AMENDMENTS TO THE DRAWINGS:

REMARKS

APPENDIX A

Fig. 1

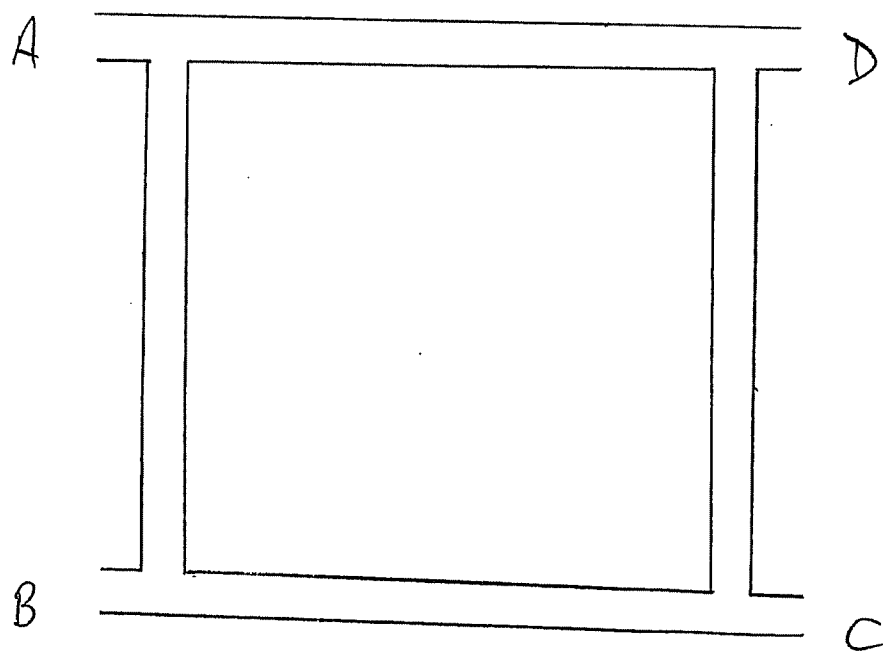
13. A second contribution to phase spoiling for Thomas 72 arises as follows. A physical view of each of the hybrids 174A and 174B in Figure 7 of Thomas 72 appears in Figure 1 of the first drawing sheet accompanying this ANNEX. Each of these hybrids is square in shape with inputs A and B and outputs C and D connected to one pair of adjacent central antenna elements E5/E6 or E7/E8 (not shown). At operating frequency, each side of the

square is $\frac{1}{4}\lambda$ long or 90° in terms of phase change: this phase change is relative between outputs, it being necessary to apply 180° to get absolute phase.

14. Input A is isolated from input B, and a signal which is input at A is equally split between outputs C and D. A signal passing along one side of the square from input A to output D has 90° phase change, but along two sides of the square from input A to output C a signal has 180° phase change. Similarly a signal passing from input B to output C has 90° phase change, but a signal passing from input B to output D has 180° phase change.
15. Let V_A and V_B be signals input to A and B respectively, ω be signal angular frequency, and V_C and V_D be signals output at C and D respectively.

Fig.9.

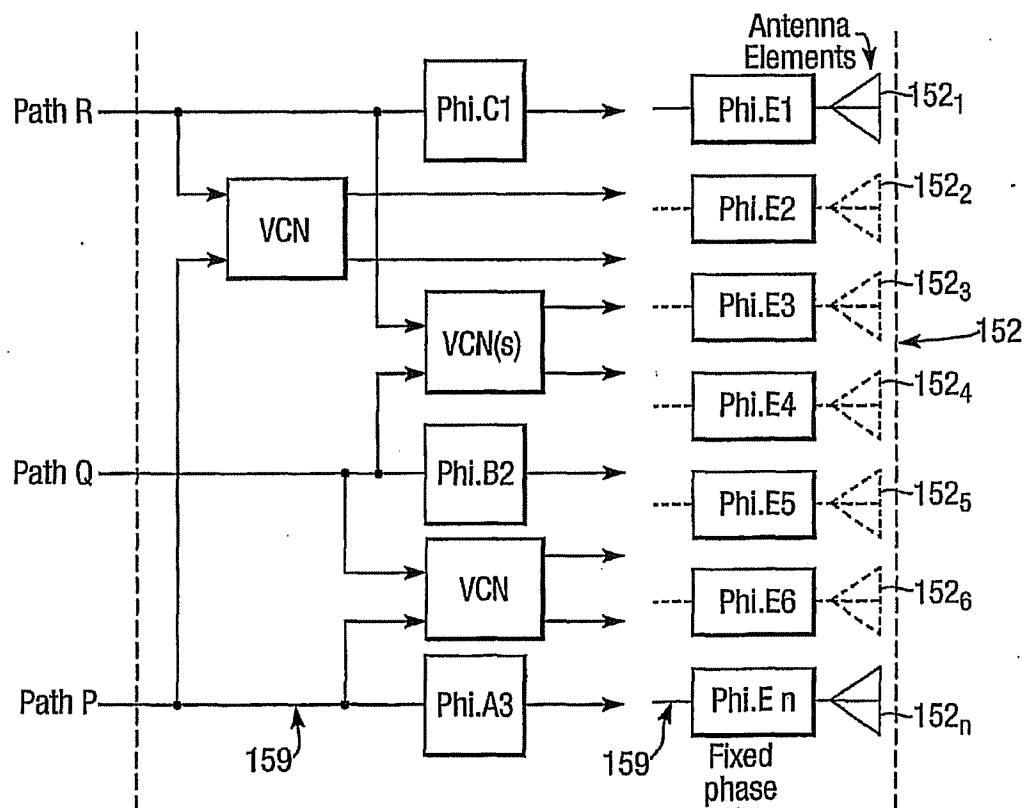
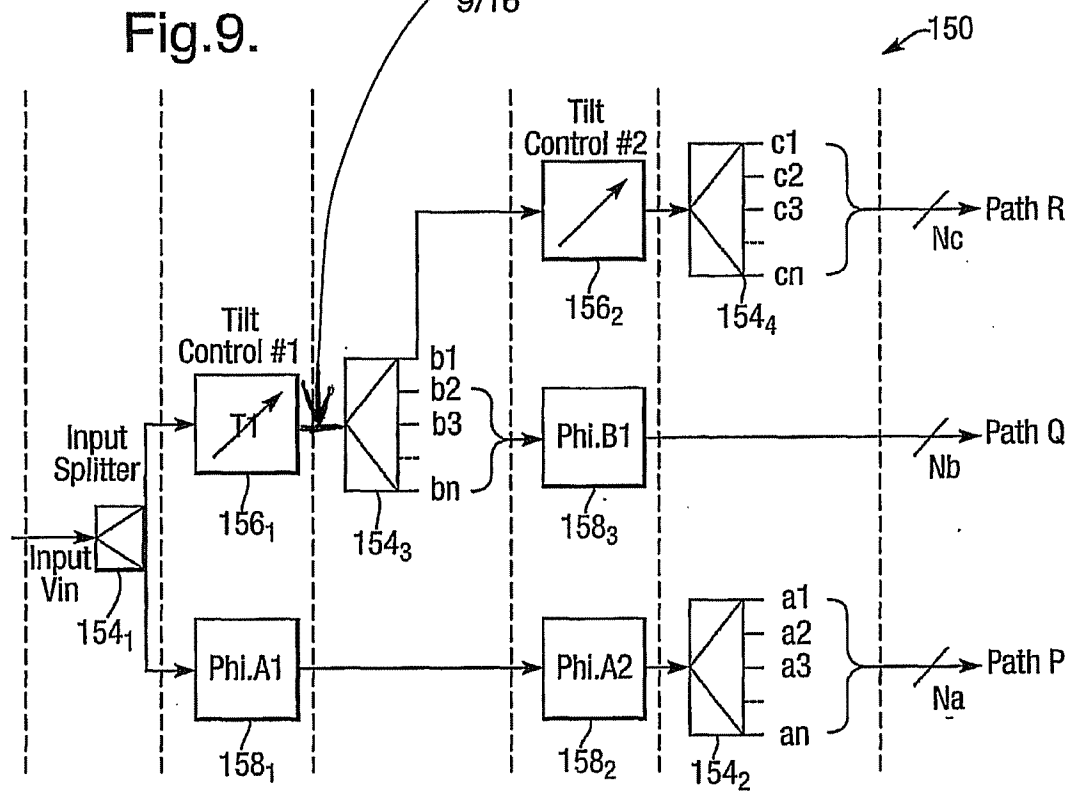
The attached drawing sheets include marked up and clean amended versions of Figure 9. Figure 9 is amended to insert a missing link between the center of the vertical right hand side of tilt control 156₁ and the center of the vertical left hand side of splitter 154₃. This amendment to Figure 9 finds support in at least Figure 3 which shows the same link between tilt control 46 and splitter 52.

link to be inserted
